Seagate Technology
10323 West Reno (West Dock)
Oklahoma City, OK 73127-9705
P.O. Box 12313
Oklahoma City, OK 73157-2313
Tel: 405-324-3070
Fax: 405-324-3794
gene_milligan@notes.seagate.com

10/15/2000
John Lohmeyer
T10 Chairman

Subject: Proposal to replace the TBDs for Fast 160 in SPI-4 and to winnow the options

Figure 50 - LVD receiver mask =< Fast 80

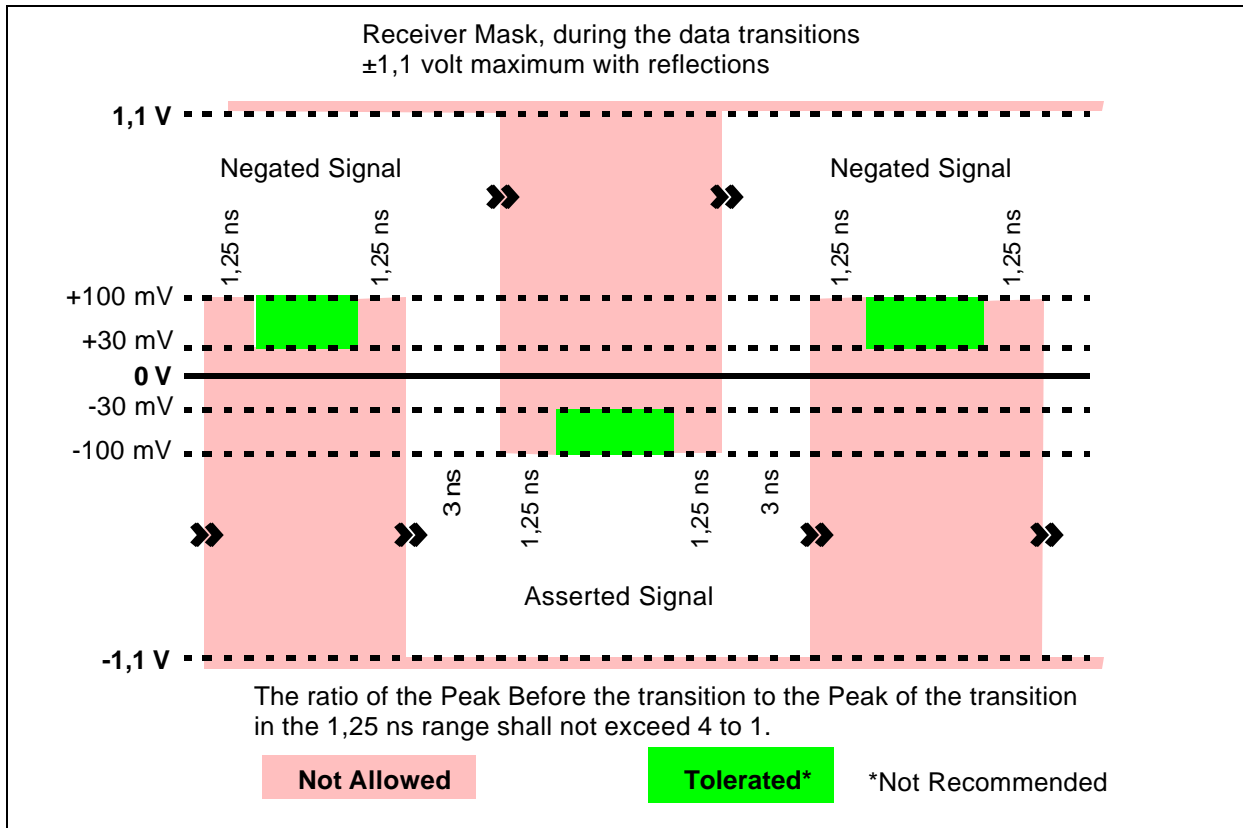
For **Fast 80** the signal shall transition from -100 to +100 mV or +100 to -100 mV in 0 to 3 ns, the waveform between -100 and +100 mV is not otherwise specified. The absolute value of the signals shall remain above the 100 mV level for 1,25 ns at each end of the transition. The absolute value of the signals shall not drop below 30 mV except during the transitions (see 7.3.2).

Proposer's note: The above text has been moved from below Figure 49 to below Figure 50.

Figure 1 - LVD receiver mask 1 = Fast 160

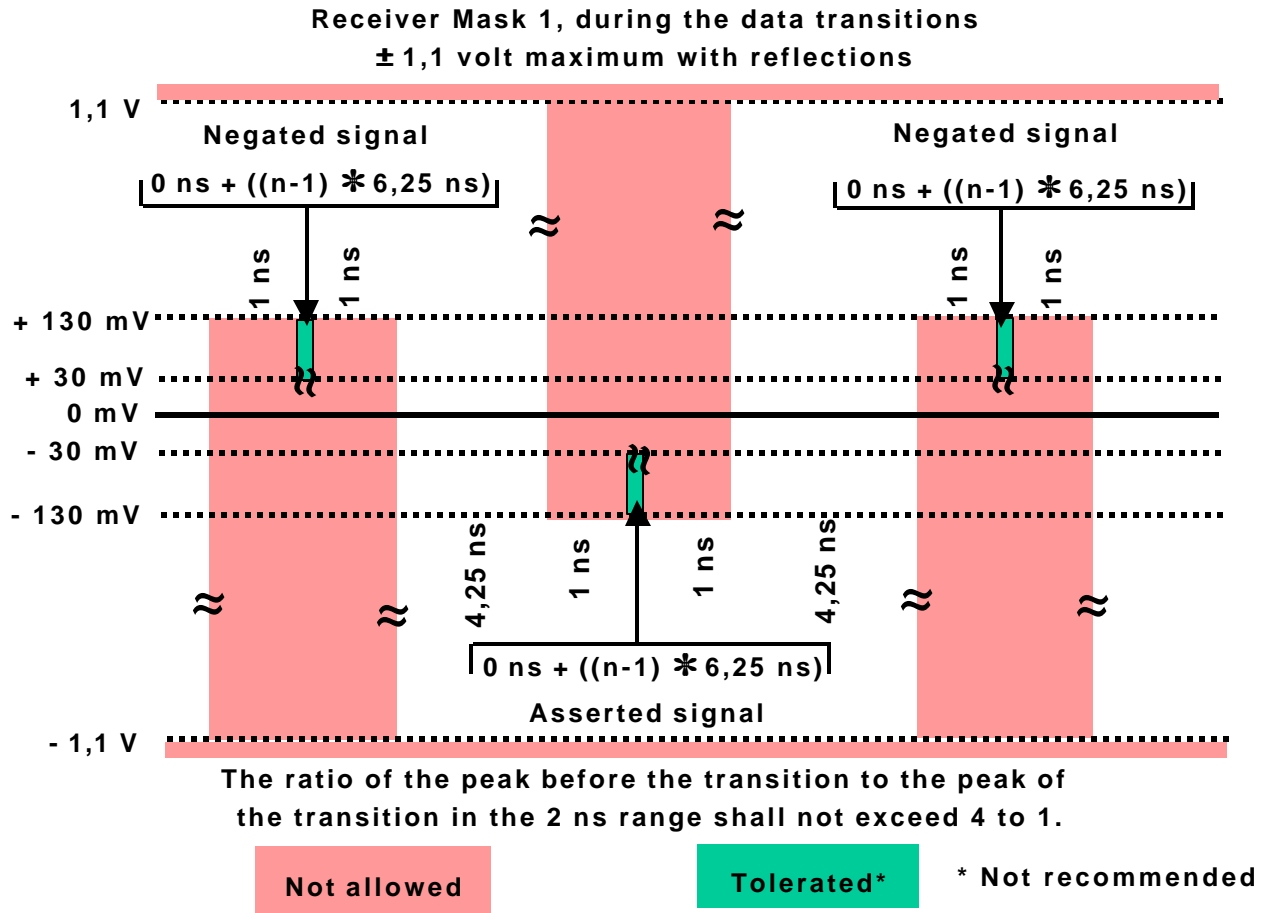
Proposer's note: This is Figure 51.

For Fast 160 the signal shall transition from -130 to +130 mV or +130 to -130 mV in 0 to 4,25 ns, the waveform between -130 and +130 mV is not otherwise specified. The absolute value of the signals shall remain above the 130 mV level for 1 ns at before and after each transition.

Figure 2 - LVD receiver mask 2 = Fast 160

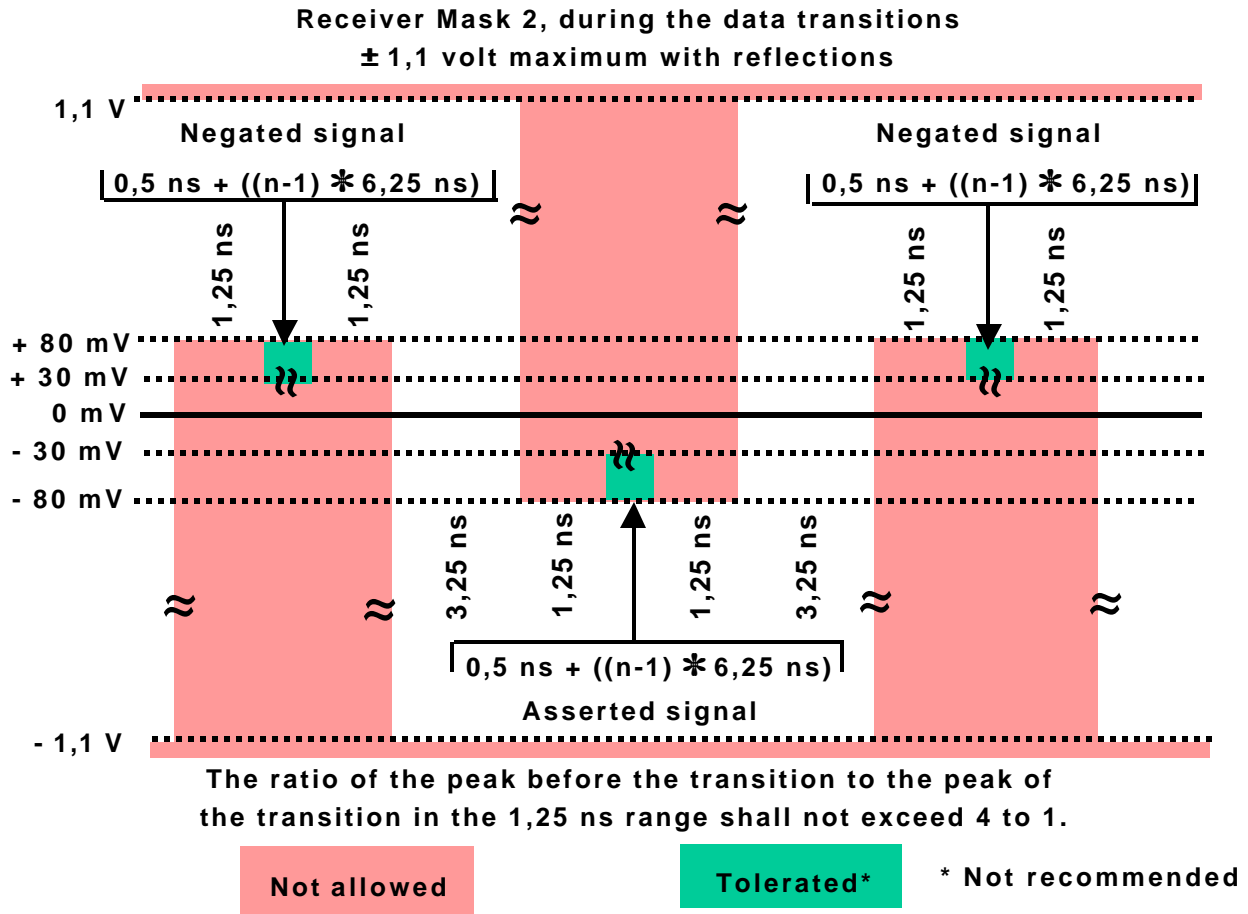
Proposer's note: This is Figure 52.

Alternatively, for Fast 160 the signal shall transition from - 80 to + 80 mV or + 80 to - 80 mV in 0 to 3,25 ns, the waveform between - 80 and + 80 mV is not otherwise specified. The absolute value of the signals shall remain above the 130 mV level for 1,25 ns before and after each transition. The absolute value of the signals shall not drop below 30 mV except during the transitions (see 7.3.2).

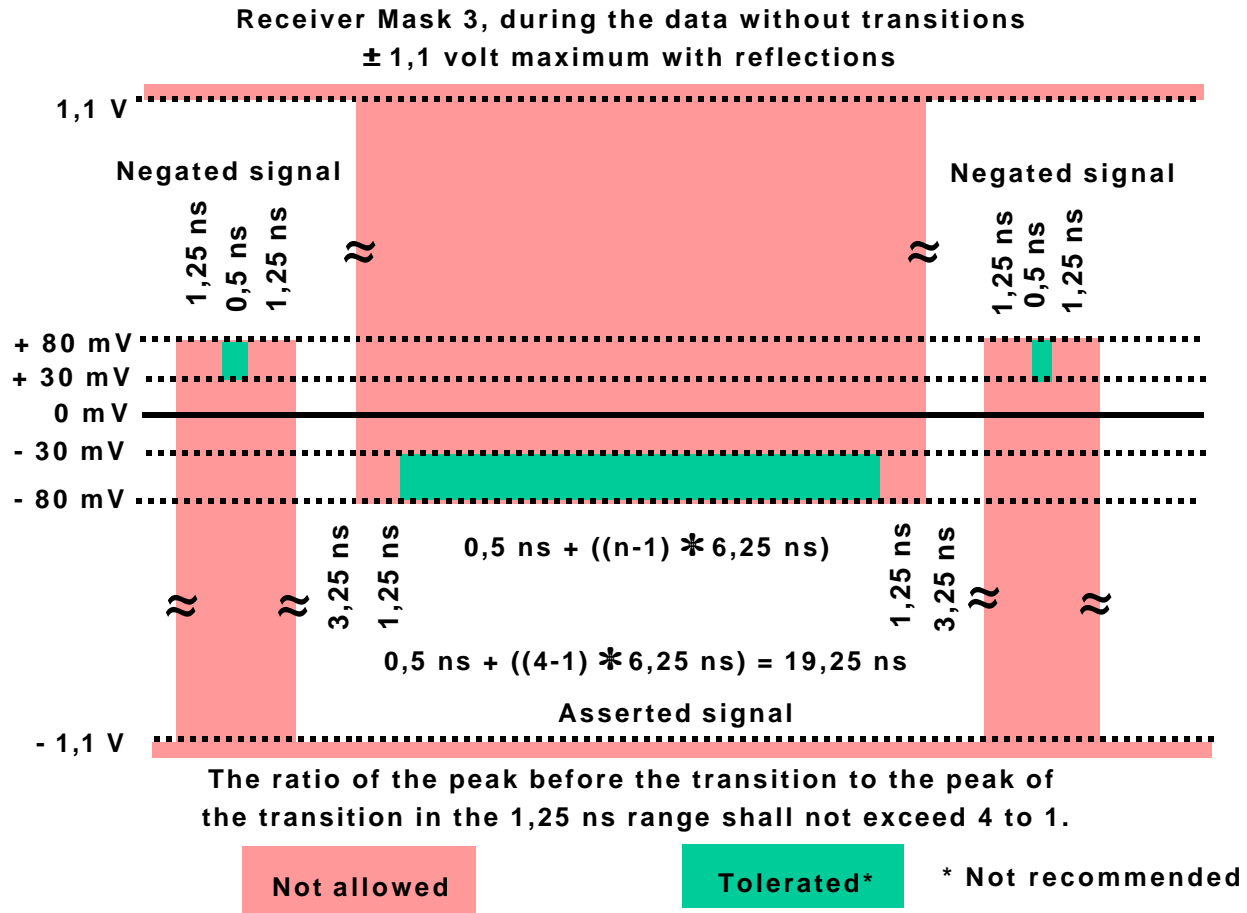
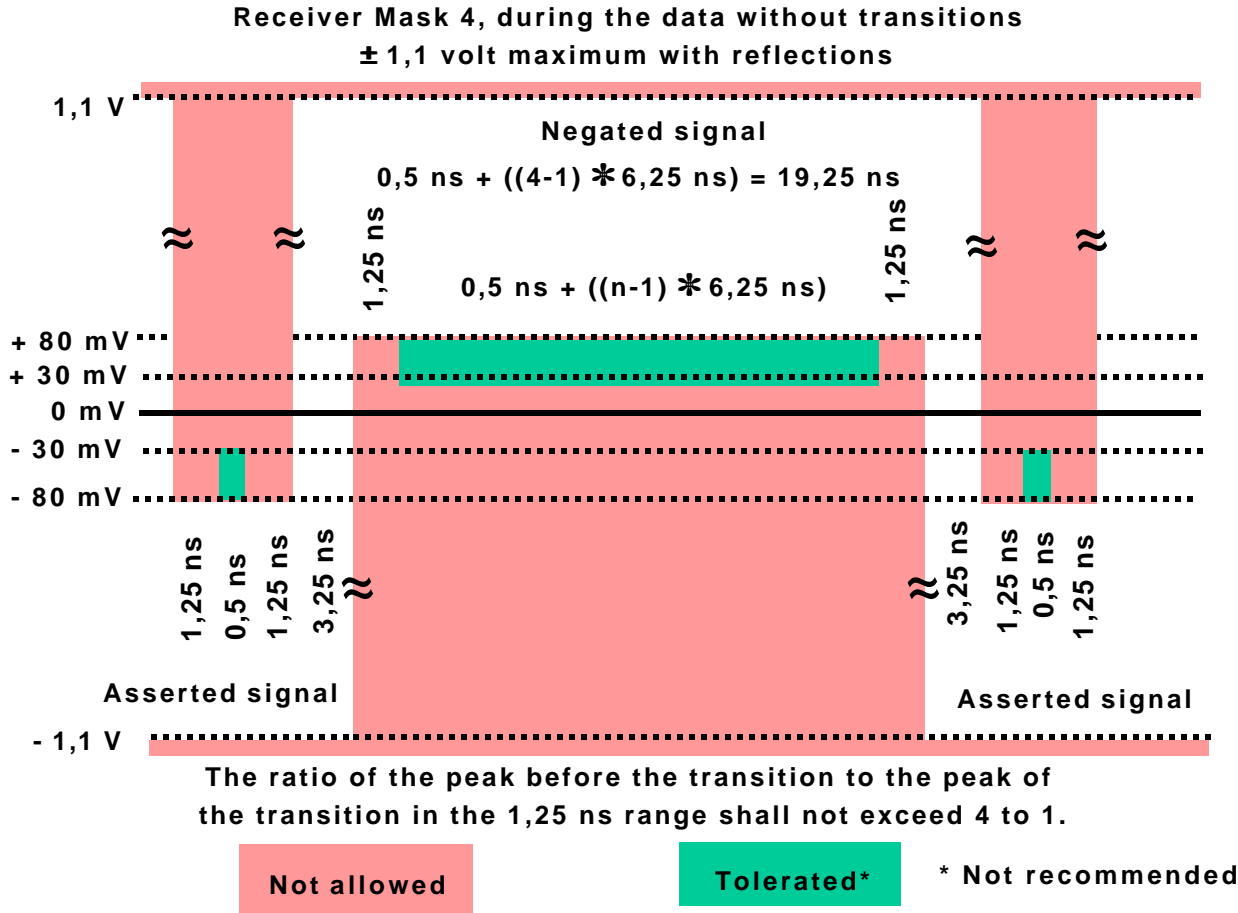
Proposer's note: Mask 3 and mask 4 are not proposed to be included in SPI-4. Rather they are illustrations of the application of mask 2 cases where the data is not alternating. Mask 3 is an example of a zero followed by four ones followed by a zero. Mask 4 is an example of a one followed by four zeros followed by a one. Similar masks could be drawn to illustrate the application of mask 1 to cases where the data is not alternating.

Figure A.1 - Domain for driver assertion and negation levels for Fast <160

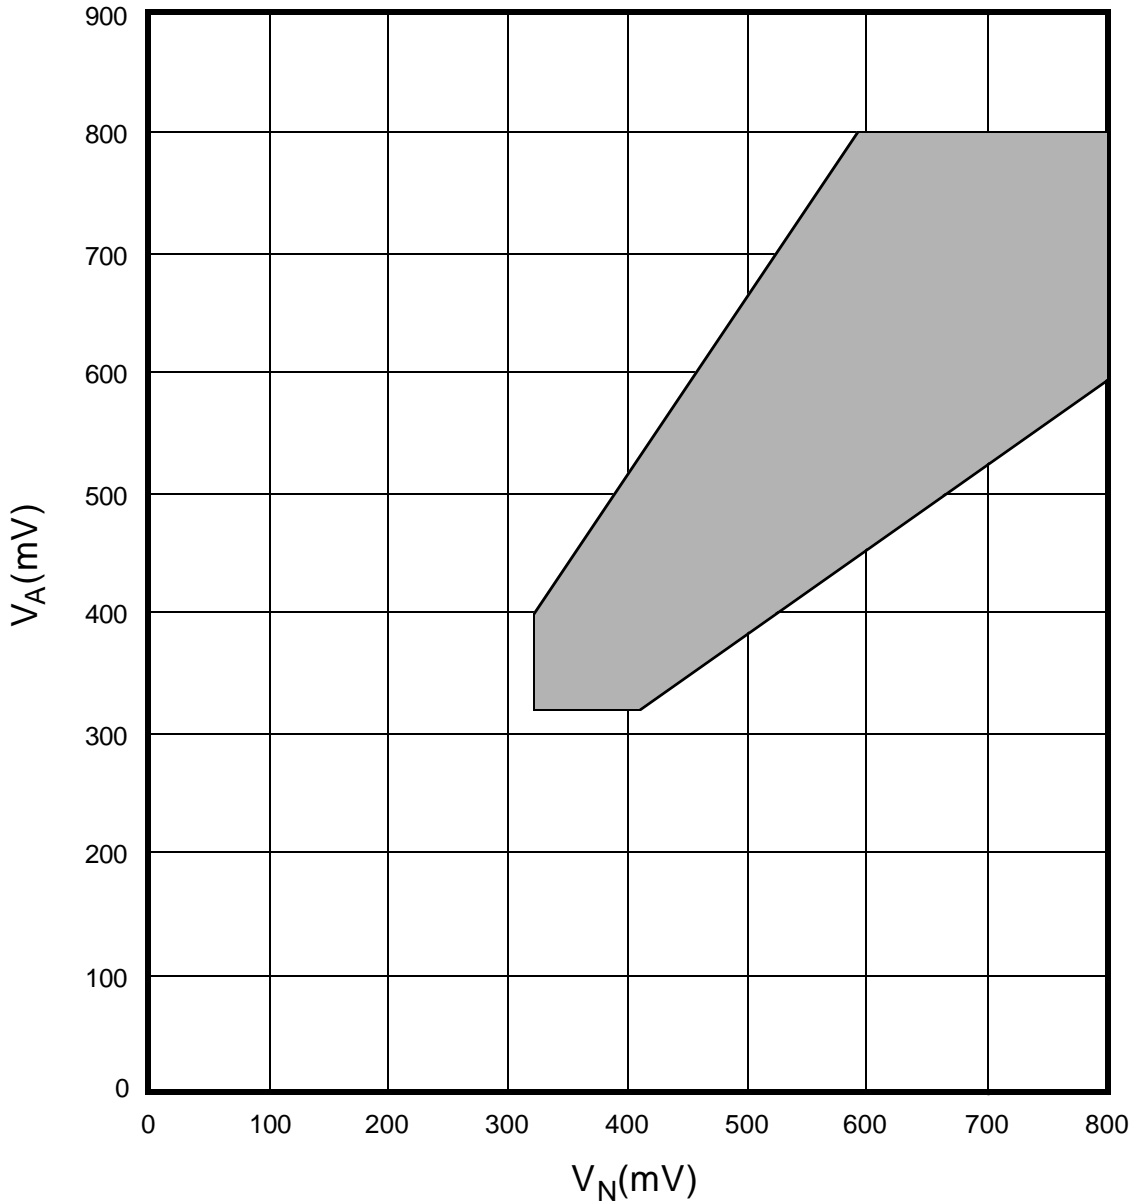
Proposer's note: The above figure should be Figure A.2.

Figure A.2 - Domain for driver assertion and negation levels for Fast 160

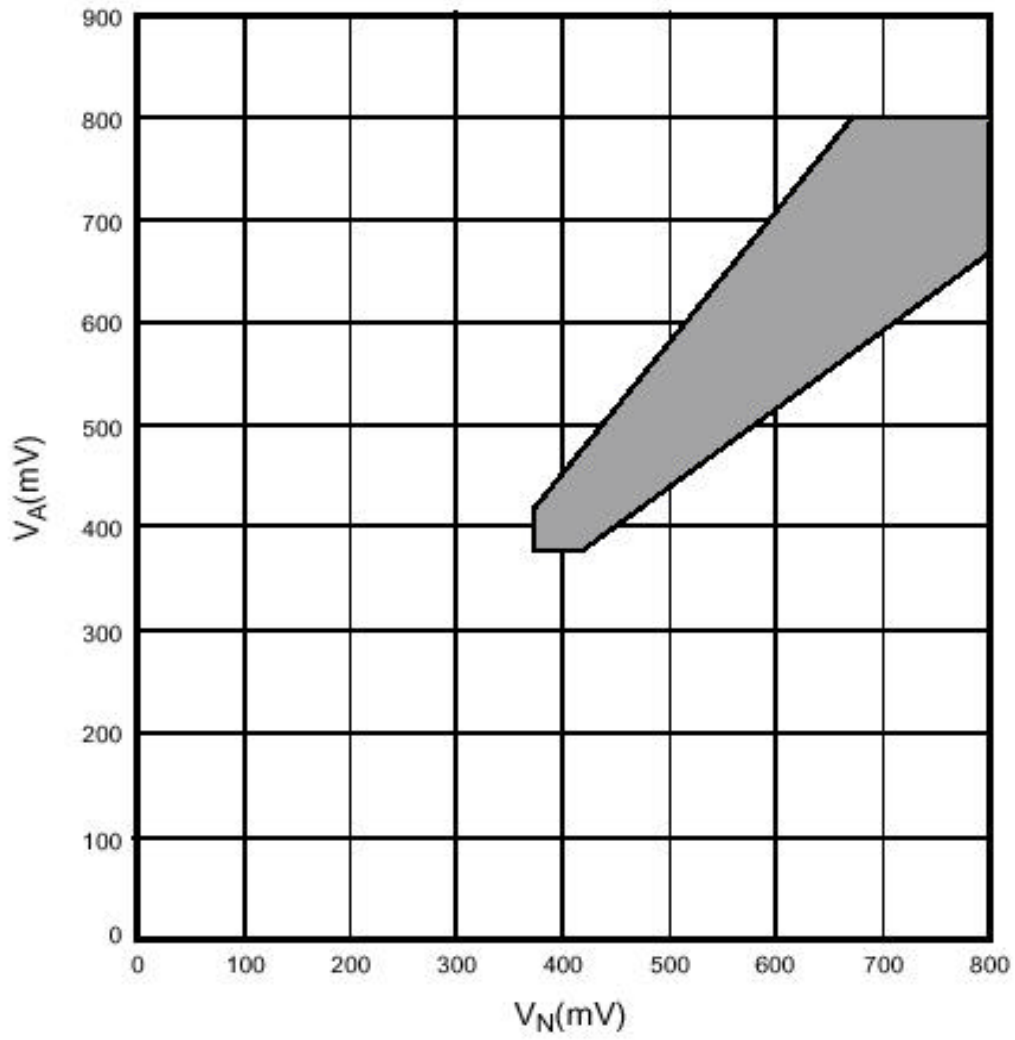
Proposer's note: The above figure should be Figure A.3.
